# Access Compliance Report

## Public Rights-of-Way

Intersection ID: 29951	Main Street: SMITH_CORNERS_BV	Cross Street: STATESVILLE_RD	Location: SW
ADA ID: 38CF09888A16	Ramp Type: Perp	Initial Pass/Fail: Fail	Overall Compliance: No
Codes/Mitigation Info/Possible Solution		Field Measurements/Component Compliance	
Severity Score: 10

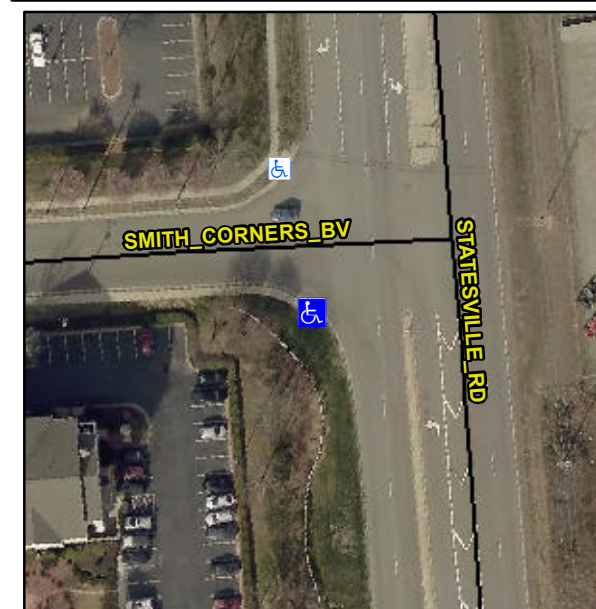
**Not Found, R304.5.1, R304.5.3**

Compliance	Description	Data	Compliance	Description	Data
N/A	Ramp Length (in)	49.0	Yes	Ramp Slope (%)	6.2
No	Ramp Width (in)	46.5	No	Ramp XSlope (%)	4.9
N/A	Flare Type LT	N/A	N/A	Flare Type RT	N/A
N/A	Flare Slope LT (%)	N/A	N/A	Flare Slope RT (%)	N/A
N/A	Flare Traversable LT?	N/A	N/A	Flare Traversable RT?	N/A
N/A	Landing Length (in)	N/A	N/A	DWS Provided?	N/A
N/A	Landing Width (in)	N/A	N/A	DWS Contrast?	N/A
N/A	Landing Slope (%)	N/A	N/A	DWS Length (in)	N/A
N/A	Landing X Slope (%)	N/A	N/A	DWS Full Width?	N/A
N/A	Landing Curb? (Y/N)	N/A	N/A	DWS Offset (in)	N/A
N/A	Shared Landing?	N/A			
N/A	Gutter Ponding?	N/A	N/A	Gutter Slope (%)	N/A
N/A	Gutter Lip Ht (in)	N/A	N/A	Gutter X Slope (%)	N/A
N/A	Painted X Walk1?	No	N/A	Painted X Walk2?	N/A
	X Walk 1 Direction	To N		X Walk 2 Direction	N/A
N/A	X Walk 1 Width (in)	N/A	N/A	X Walk 2 Width (in)	N/A
	X Walk 1 Slope (%)	0.5		X Walk 2 Slope (%)	N/A
	X Walk 1 X Slope (%)	5.3		X Walk 2 X Slope (%)	N/A

**Remove & Replace Entire Ramp.**
